8562EC-04

S E R V I C E N O T E

856xEC Series Portable Spectrum Analyzer

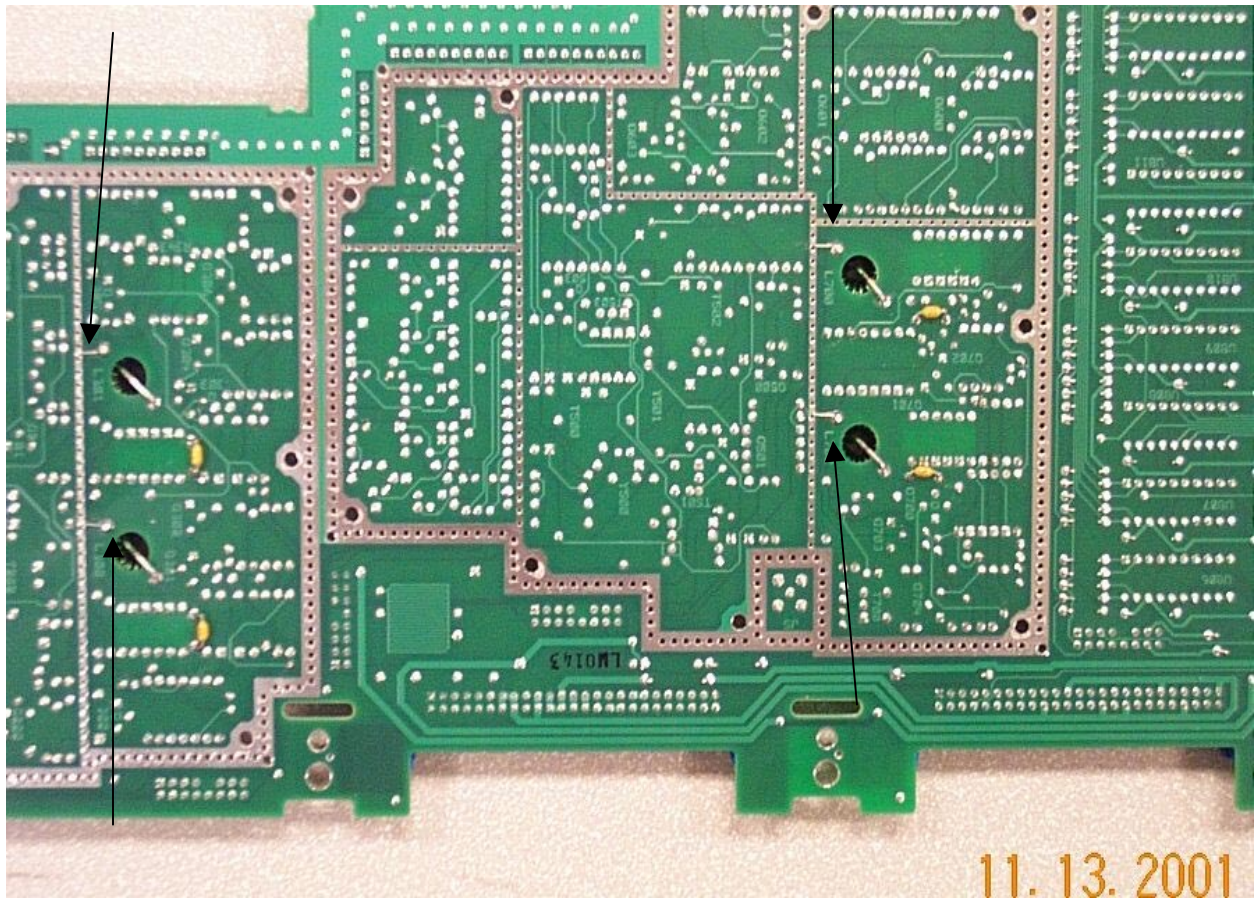
For the instruments specified above, inductors within the A5 IF assembly are not making good connections to ground thereby giving error messages related to the A4 Log Amp board. Error numbers that appear in the lower right-hand corner of the screen on account of this problem are errors 561, 562, and 565.

If the serial number of the instrument applies to the ones above, the following butch may solve the problem. Remove the shielding from the A5 IF assembly. Locate the inductors, and according to the attached photograph, insert and solder one end of the 8150-4222 wire into the hole connecting to the inductors and solder the other end to the ground plane on the front layer of the board. Do this for each inductor. See attached picture, the arrows point to where the jumpers are attached.

Add jumpers according to the picture above.
